Enquiries: Kieren Nyko
Our Ref: CA 2025_5880/1 (1363256)
Your Ref: 2025-09-82 – Seymour Group

INFORMATION REQUEST
(Given under Section 12 of the Development Assessment Rules)

Street Address: 71-85 Port Douglas Road, Port Douglas
Real Property Description: Lot 1 on SP150468
Local Government Area: Douglas Shire Council

Application Number: CA 2025_5880/1
Approval Sought: Development Permit
Nature of Development Proposed: Reconfiguring a Lot and Material Change of Use (Variation Request)
Description of the Development Proposed: Combined Application – Preliminary Approval for use rights associated with the Low Medium Density Residential Zone and Development Permit for Reconfiguring a Lot (1 Lot into 40 Lots and Common Property)

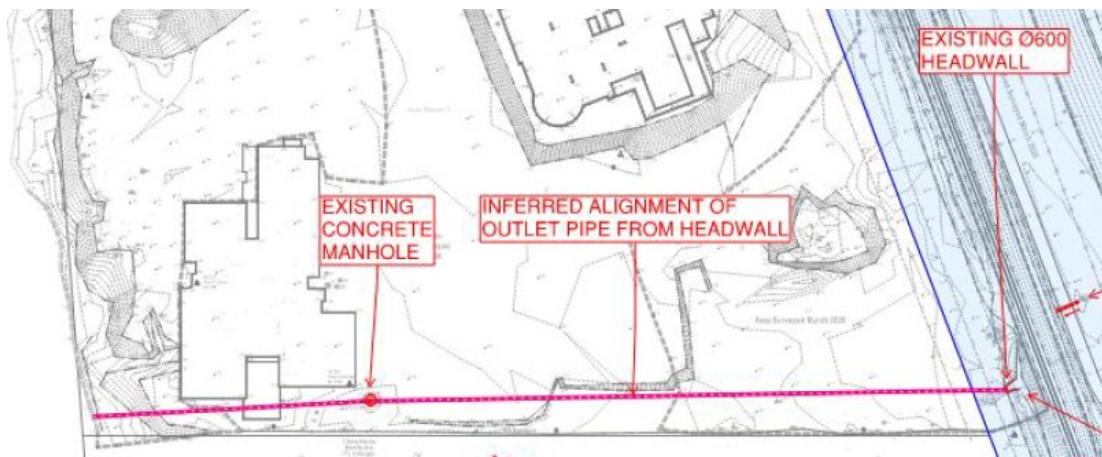
Advice Note: A total of 18 on-street parallel vehicle parking spaces are proposed within the road pavement area. Furthermore, the frontage of proposed Lots 04, 05, 11, 12, 13, 14, 15, 28, 29, 30, 31 are entirely constrained by a parallel vehicle park or

driveway, Officers consider that the development has not given due consideration to kerb-side waste collection for these proposed lots.

Additionally, no measurements have been provided on the proposed plan of development to show the dimensions of the vehicle parking spaces or the separation between the on-street parallel parking spaces and the indicative driveway locations.

16. Provide an updated Plan of Development which provides an appropriate outcome for kerbside refuse collection.

Extract of existing drainage from site Drainage Report 31/08/2020

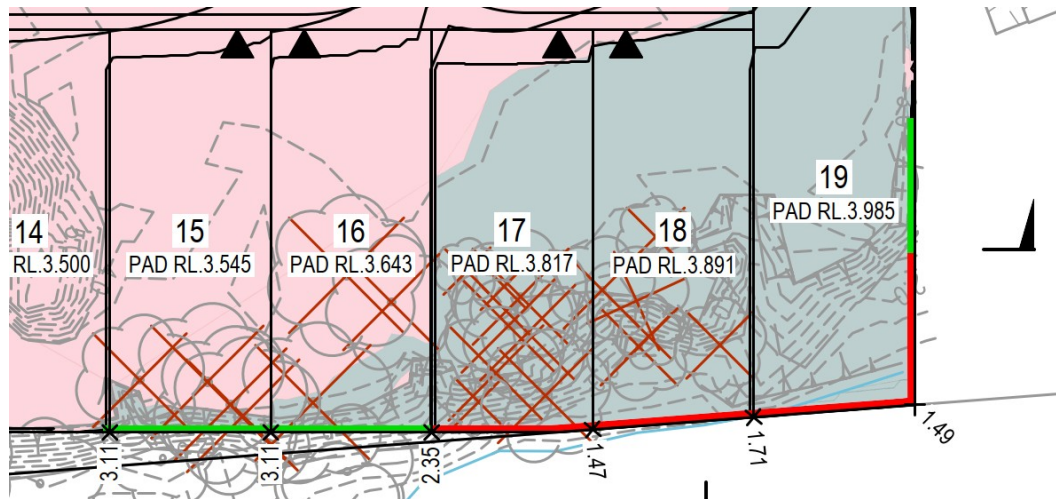
17. Provide a local drainage study confirming how the external road reserve drainage will be managed in the proposed development layout. The development layout must be amended to reflect existing stormwater piped drainage and overland flow paths through the site. Additional information is required to demonstrate how the existing drainage will be maintained and accommodated within the development layout.

Advice Note: Previous development proposals for this site included drainage corridors from Port Douglas Road through the site to the west. The lot layout must demonstrate external stormwater from within in Port Douglas Road is conveyed through the site and not directed onto third-party landowners.

18. Provide confirmation that the existing surface levels within the road reserve will be regarded to maintain free draining conditions between the site and the road carriageway for Port Douglas Road;
19. Provide calculations on the detention basin sizing and confirm that the proposed basin volume can mitigate the development impacts of the site to pre-development conditions.
